Spartan Fire, LLC

Technical Service Bulletin
RSB21-250-001

CONDITION: Loose Reyco IFS Steering Gear Box Bolts

Service Bulletin SGM 0121

Bolts Used in Steering Gear:

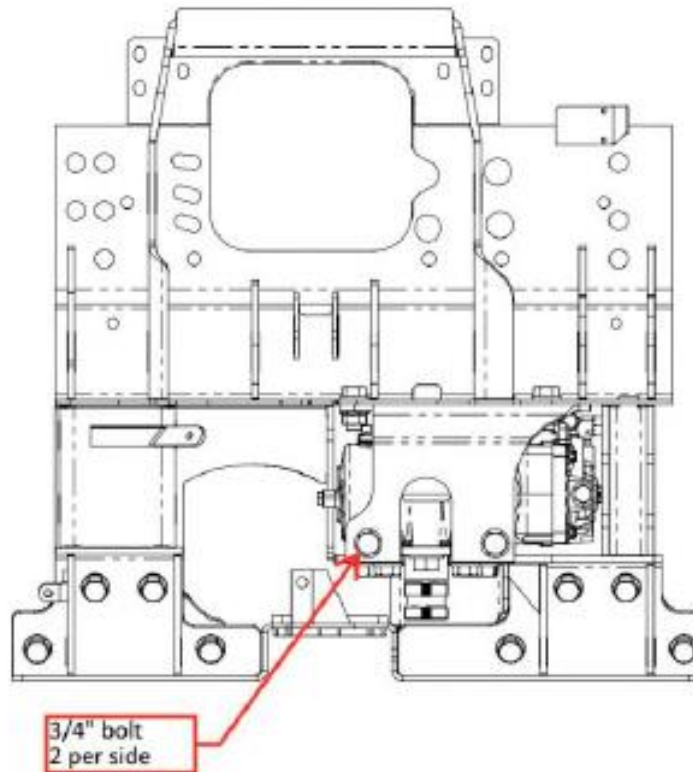
709388-03 3/4-16 X 1.25 GR 8 ZN (outside bottom plate, and side plate bolt)
8223752 3/4-16 X 2.00 GR 8 PO (bottom plate into steering gear) in K715597
709386-01 7/8-14 X 2, GR 8 ZN (bottom plate into steering gear) in K715597

- Remove the single 7/8 in bolt from each steering gear
- Clean the threads inside the steering gear blind hole.
- Discard the 7/8 in fastener and flat washer and install the Nord-Lock washer on the new fastener.

- Install and torque to 500 lb ft.
- Remove the (10) 3/4 in fasteners from each steering gear one at a time and clean the threads and mating holes. See images on following pages.

Cradle Side View (Suspension arms removed from view)

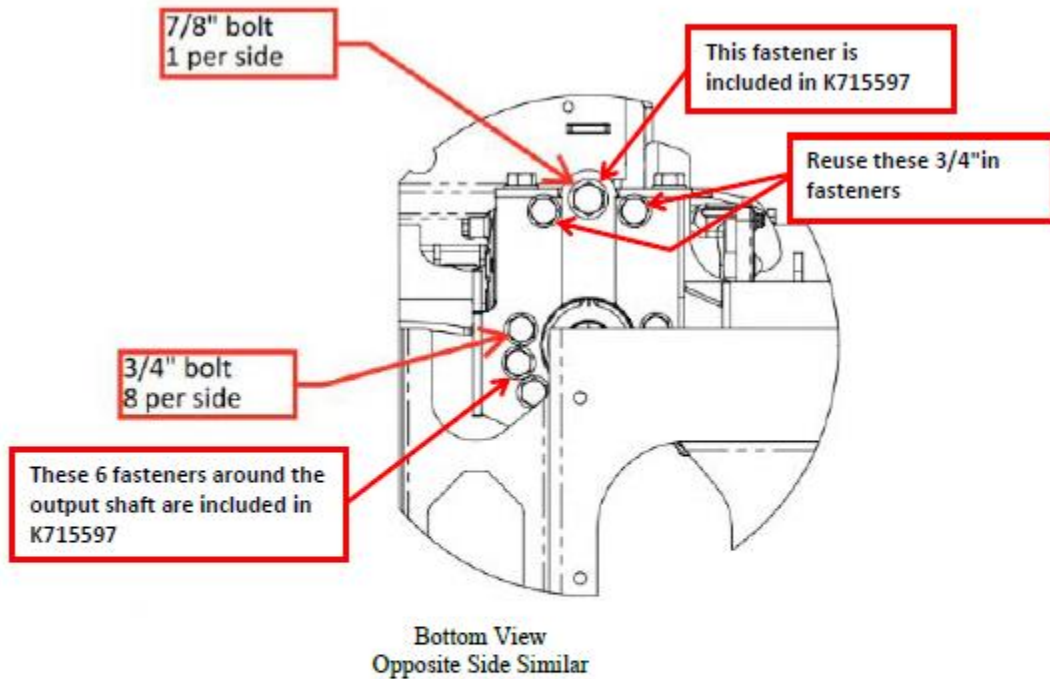
Opposite side similar

*****Reuse These Bolts*****

- o Access to all bolts may require steering the vehicle from one limit to the other.
 - o Discard the fasteners that directly thread into the steering gear and replace with new fasteners (6 fasteners directly around the output shaft of the gear)

- o Reuse the 4 fasteners that thread into the mounting plates.
- Discard the flat washer and install the appropriate Nord-Lock washer on the fastener (new fastener if applicable).
